Addendum No. 1

RE: Contract # C204498

Beaufort & Martin Counties (R-2511)

US-17 FROM WASHINGTON BYPASS NORTH OF NC-171 TO MULTI-LANES
SOUTH OF WILLIAMSTON.

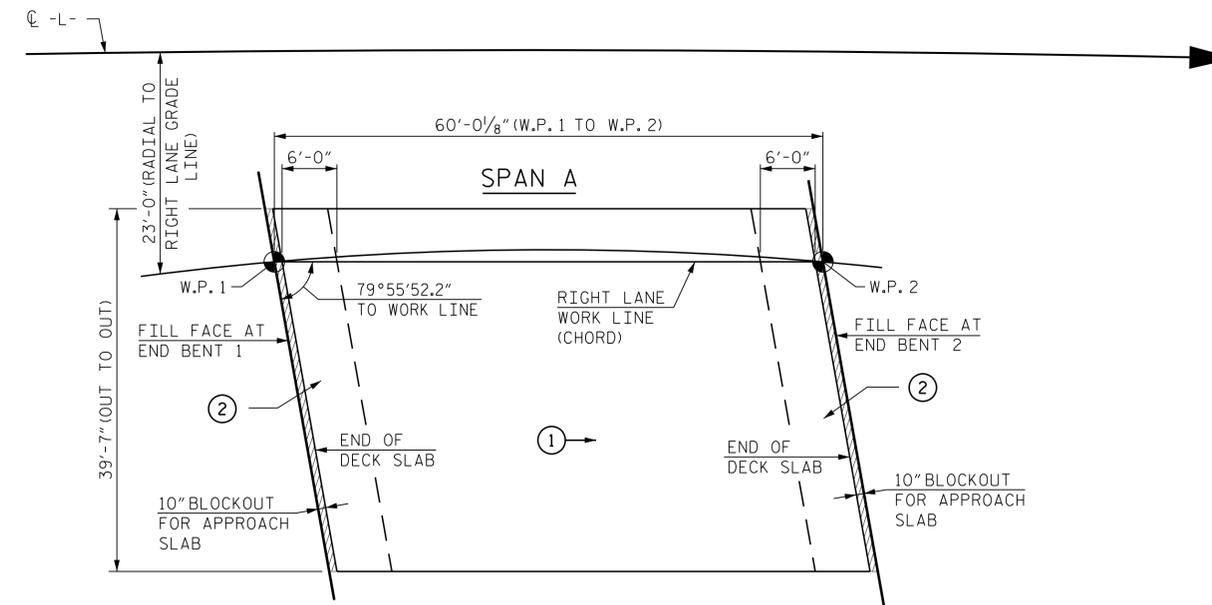
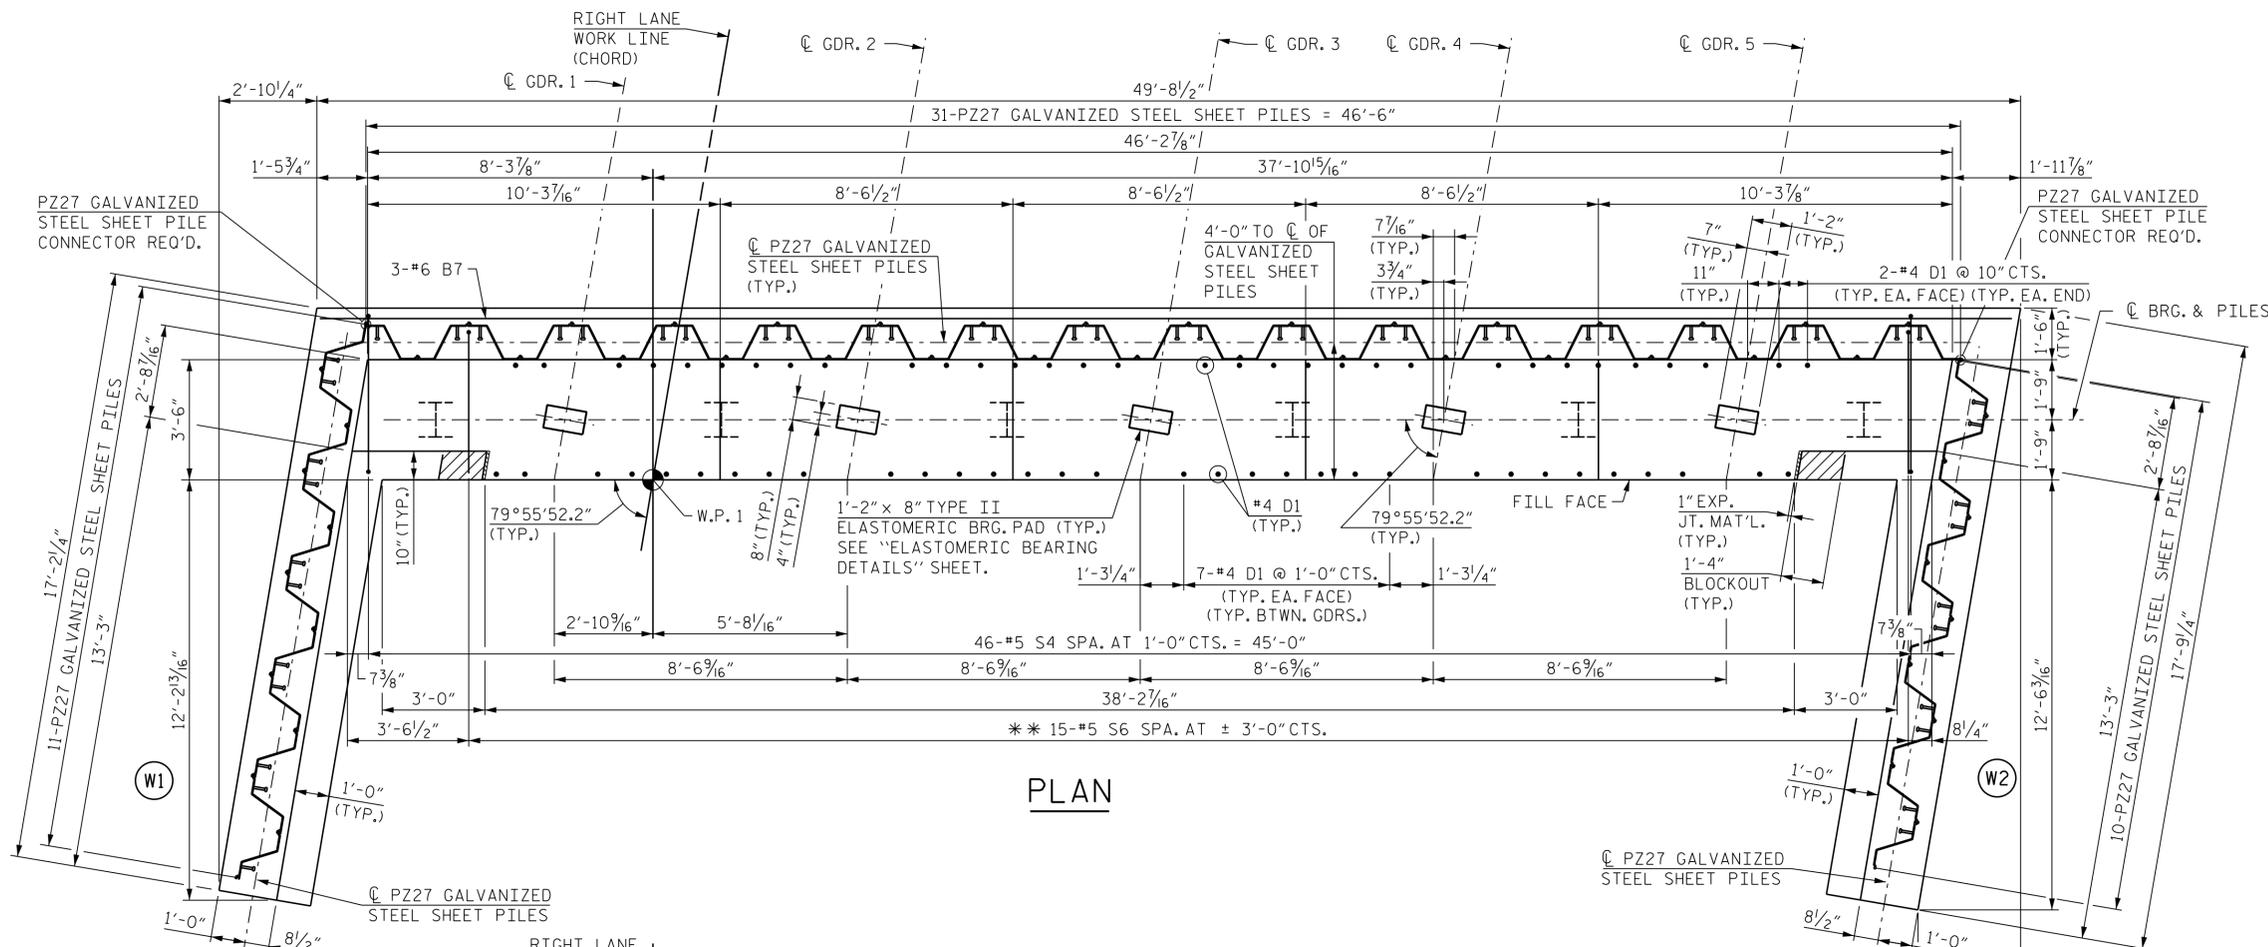
Sheet No.	Revision
SR-4	<p>Total Bill of Material updated, PZ27 Galvanized Steel Sheet Piles 7,017 SF revised to 7,017 SF of 18" Galvanized Steel Sheet Piles to match estimate.</p> <p>Unclassified Structure Excavation at Sta. 155+56.00 -L- quantity added to Total Bill of Material to match estimate.</p> <p>General Notes updated.</p> <p>Temporary shoring added to Location Sketch.</p>
Standard Notes	Replaces SR-26 in existing Bridge plans. Insert Standard Notes between Bridge Plans and Culvert Plans. Standard Notes sheet applies to all Structure Plans (Bridges and Culverts).
